REPORT ON THE RESURVEY OF THE NORTH
THORNE RIVER SALE AREA

Bruce Dinneford
Alaska Department of Fish and Game
Sport Fish Division
May 1976

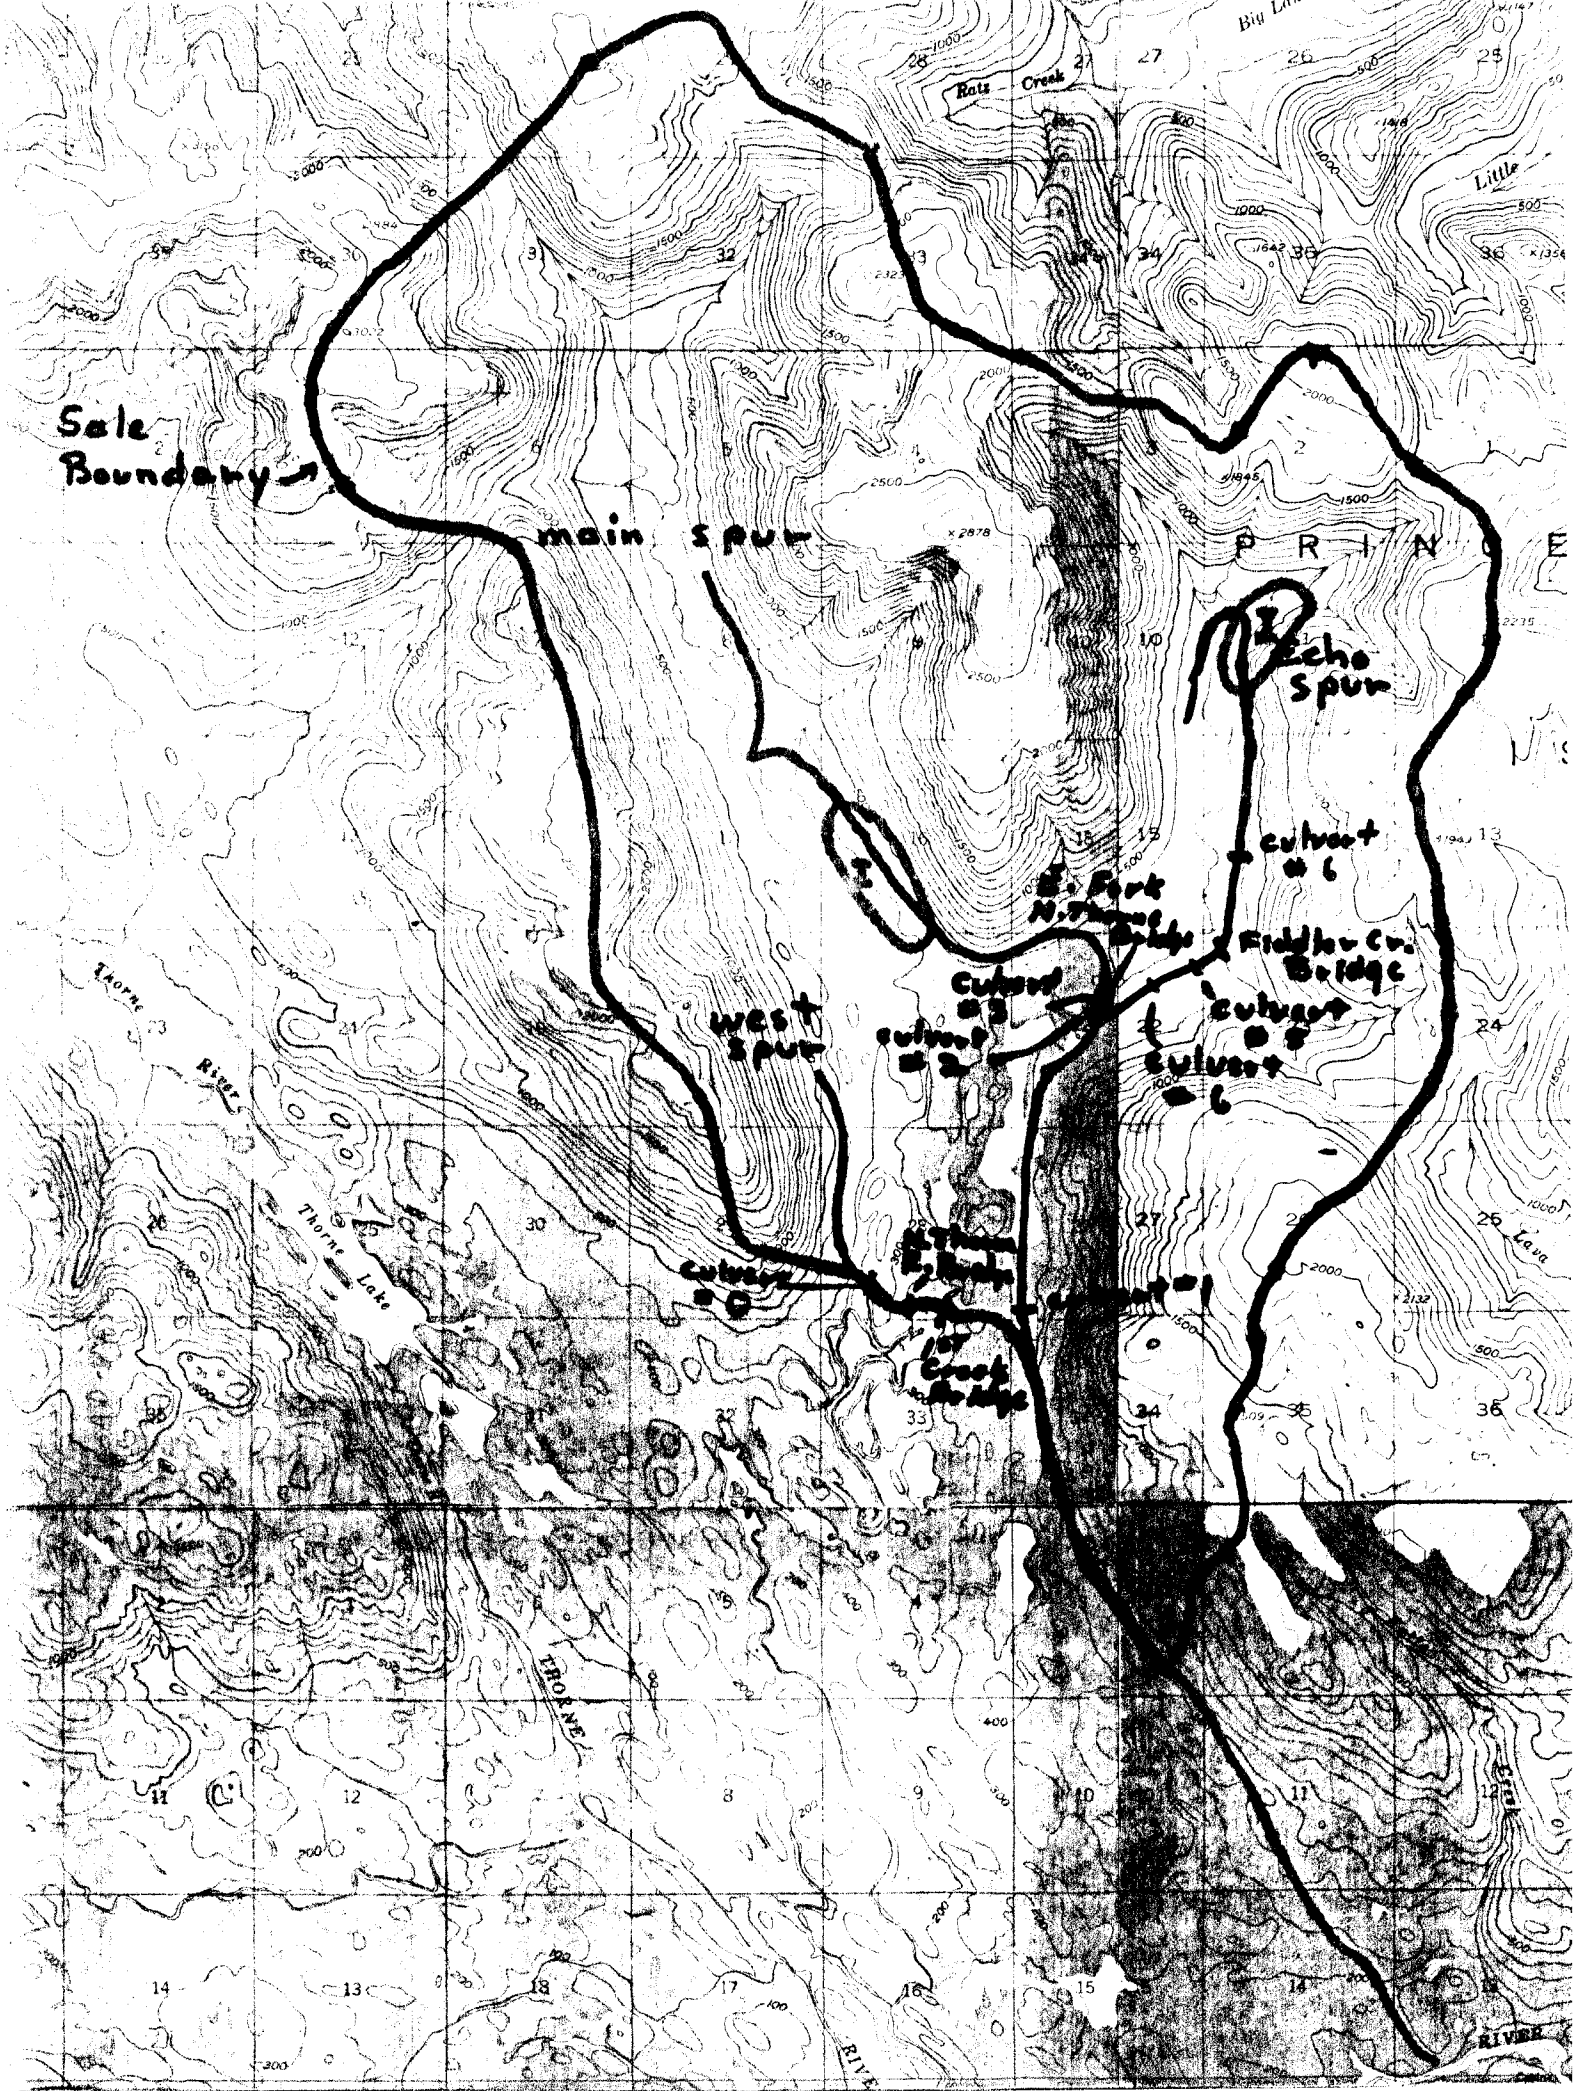
The two areas referred to above are shown on the enclosed map by the number 1. On both east fork and west fork these areas are bisected by access roads. We could not get up the main spur (west fork) far enough to see what the effect of the road placement has been due to a loading operation in the road. On Echo Spur the east branch of the east fork is very braided along the road. While this condition existed prior to road construction it is felt construction so close to the stream could trigger channel shifting. The road passes within forty feet of the stream for approximately 400 feet.

1) the east branch of the east fork (mentioned above), and 2) culvert number 5 on echo spur. While fish were not documented here, the stream runs parallel to the road, in gutter fashion, upstream from the road for 300 feet.

Culvert number one was the only definite fish stream with evidence of logging accross it. Approximately 350 feet of stream is covered with debris from an older operation. This slash may be blocking the movement of Dolly Varden since fish were trapped up to a point about 100 feet below the culvert but none were found above the culvert. No natural barriers were observed from the culvert to where fish were trapped.

Fry trapping data is inconclusive as to the culverts ability to consistently pass rearing fish. It should be noted that trap number 3, where fish were trapped above the culvert had no drop, but trap number 2, having fish below but not above the culvert, had a drop of only 3 cm.
